APPLICATION NO.	FILING DATE	FIRST NAMED INVENTOR	ATTORNEY DOCKET NO.	CONFIRMATION NO.
10/510,423	04/21/2005	Jaume Prat Terradas	30607/40513	4333

Office Action Summary	Application No. 10/510,423	Applicant(s) TERRADAS ET AL.	
	Examiner Vinh T. Luong	Art Unit 3682

ATTACHMENT 1

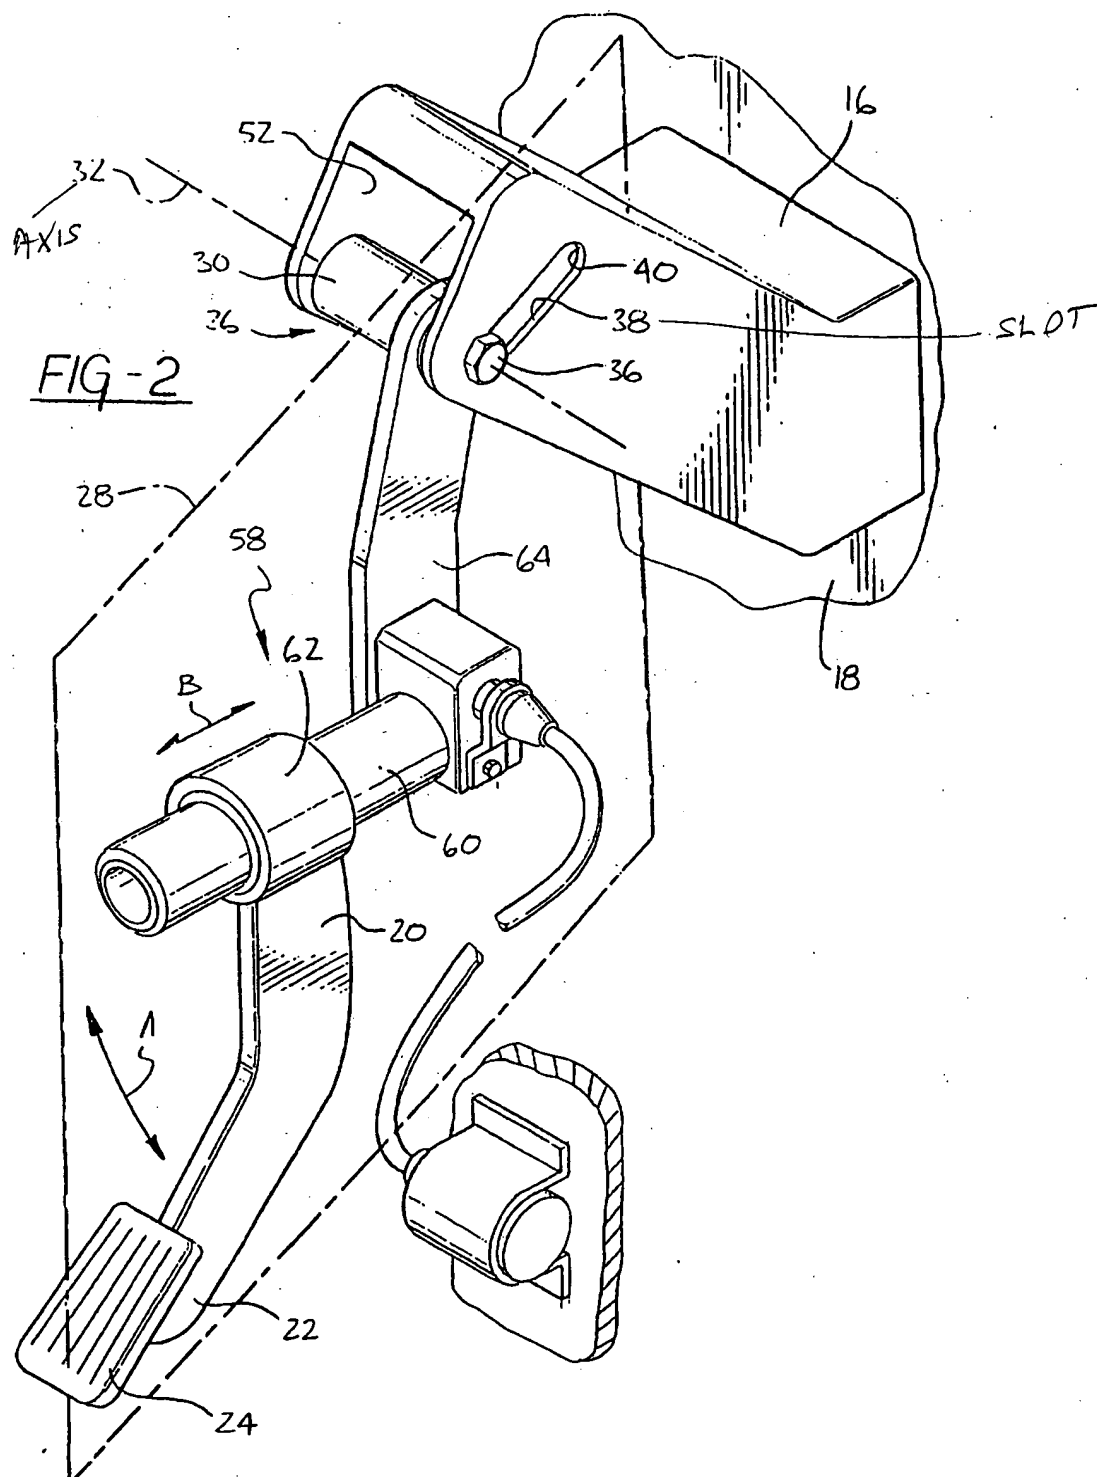
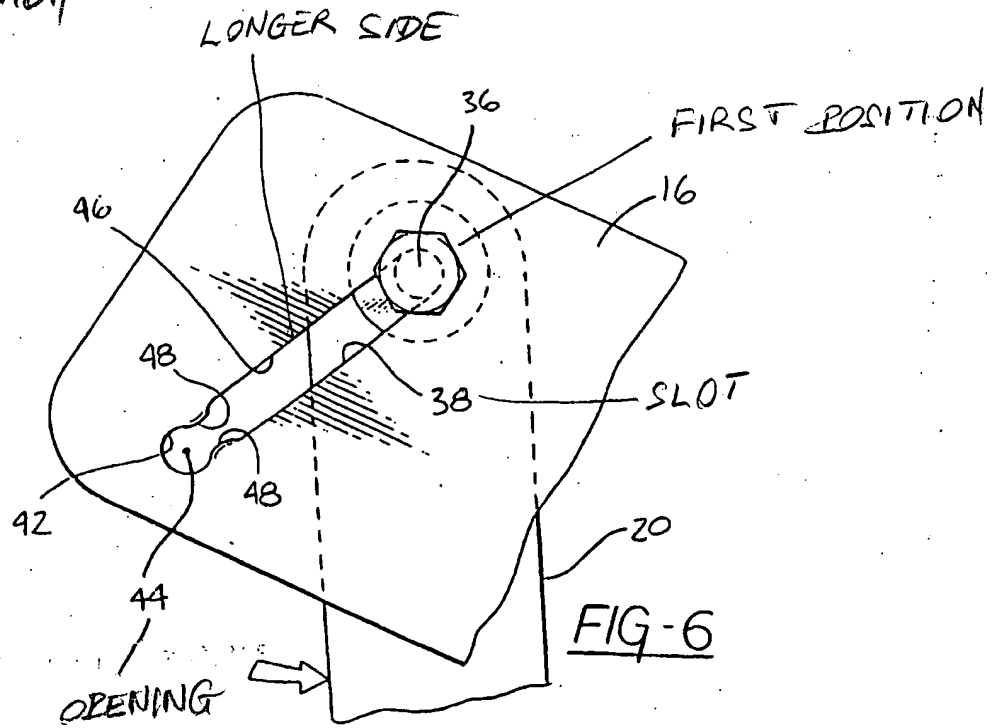
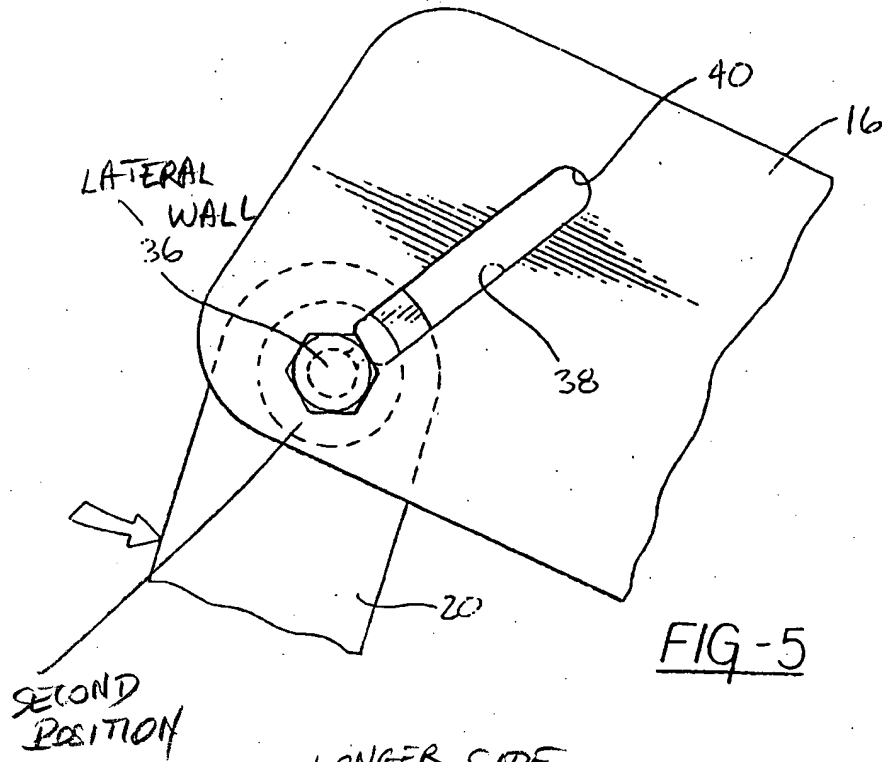
an expandable slot 38 connected to the opening 44 and defining longer sides 46 (*id.* Paragraph [0013], see Attachment 1), the expandable slot 38 comprising movable lateral walls 36 along slot longer sides 46, the movable lateral walls 36 having a first position (FIG. 6) in which the lateral walls 36 project into the expandable slot 38 and a second position (FIG. 5) in which the lateral walls 36 are moved out of the expandable slot 38, wherein the pedal axis 32 engages the movable lateral walls 36 and moves the lateral walls 36 from the first position (FIG. 6) to the second position (FIG. 5) by exceeding a mechanical limit loading of the pedal axis 32, whereby the expandable slot 38 receives the pedal axis 32. *Ibid.* claims 1-19.

ATTACHMENT 2

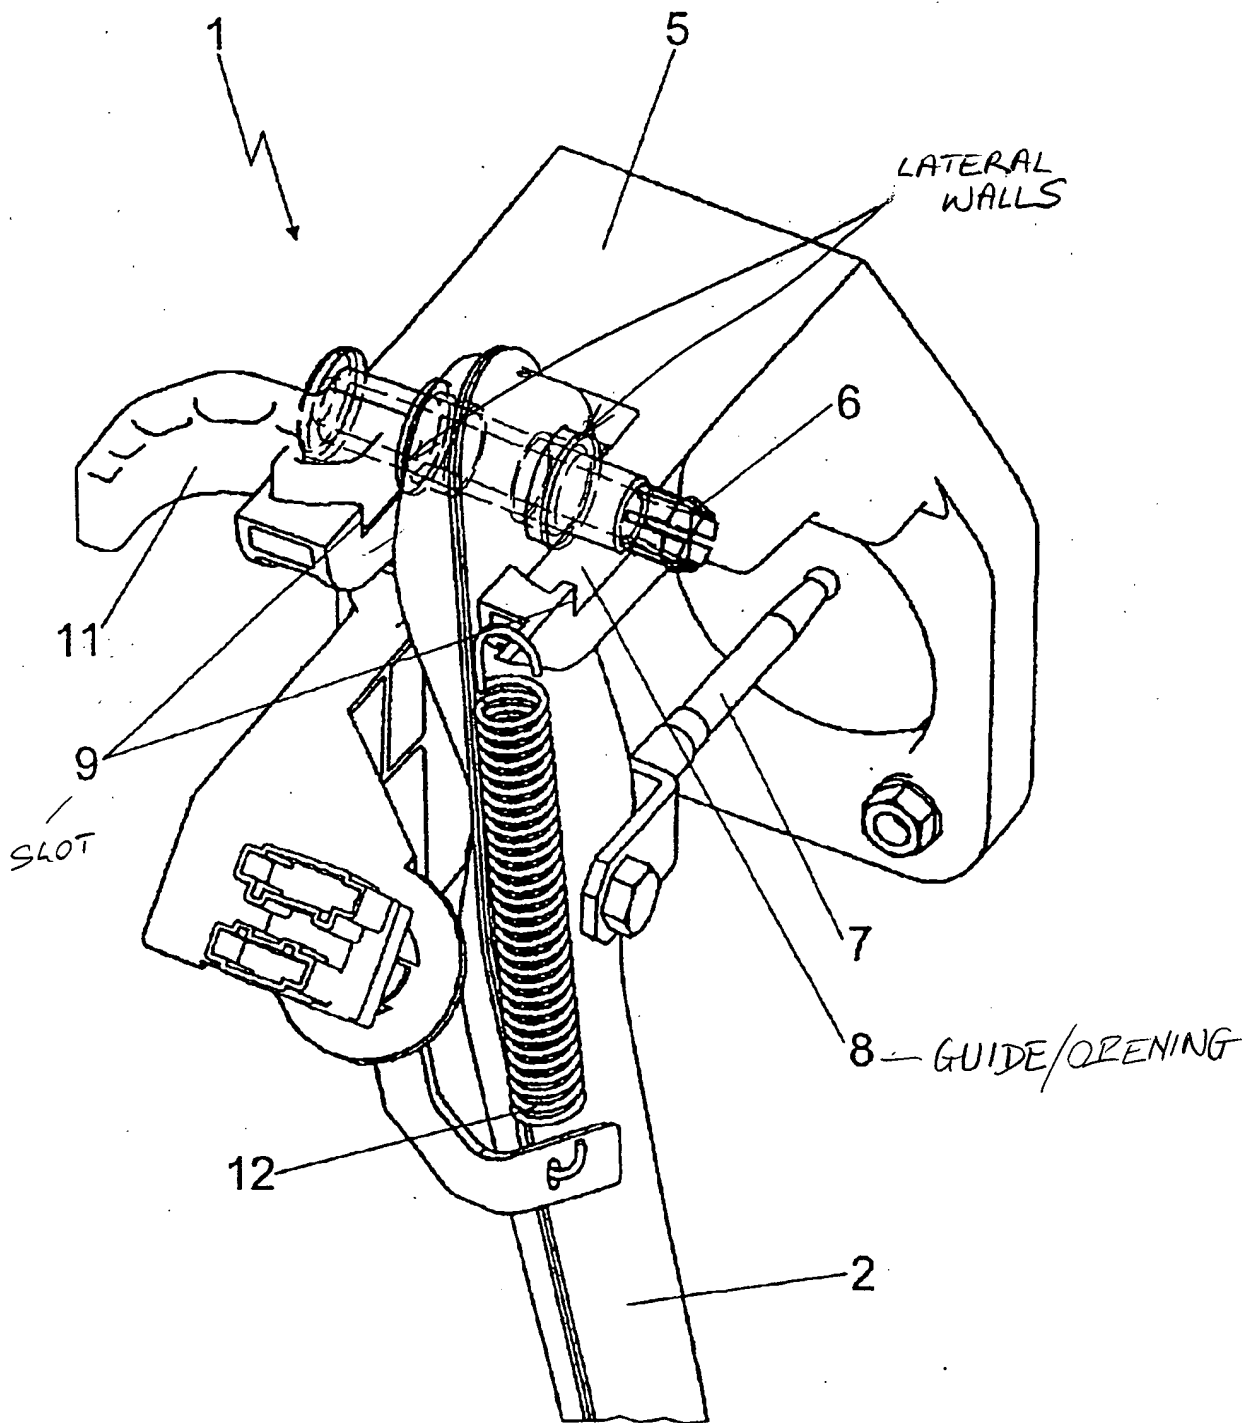
an expandable slot 9 connected to the opening 8 and defining longer sides 9, the expandable slot 9 comprising movable lateral walls (unnumbered, see Attachment 2 hereinafter "Att. 2") along slot longer sides 9, the movable lateral walls (Att. 2) having a first position in which the lateral walls (Att. 2) project into the expandable slot 9 and a second position in which the lateral walls (Att. 2) are moved out of the expandable slot 9, wherein the pedal axis 6 engages the movable lateral walls (Att. 2) and moves the lateral walls (Att. 2) from the first position to the second position by exceeding a mechanical limit loading of the pedal axis 6, whereby the expandable slot 9 receives the pedal axis 6. *Ibid.* Claims 1-16.

Regarding claim 11, the expandable slot 9 is formed by an elongated hole (FIGS. 1-5), which is partly closed by the moveable lateral walls (Att. 2) projecting therein.

Regarding claim 12, the moveable lateral walls (Att. 2) are bent, dismounted, or pushed away from the expandable slot 9 in response to the mechanical limit loading by the pedal axis 6.

Regarding claim 13, a spring 12 is coupled operatively to the lateral walls (Att. 2), wherein the moveable lateral walls (Att. 2) are pushed by said pedal axis 6 against the load of the spring 12.
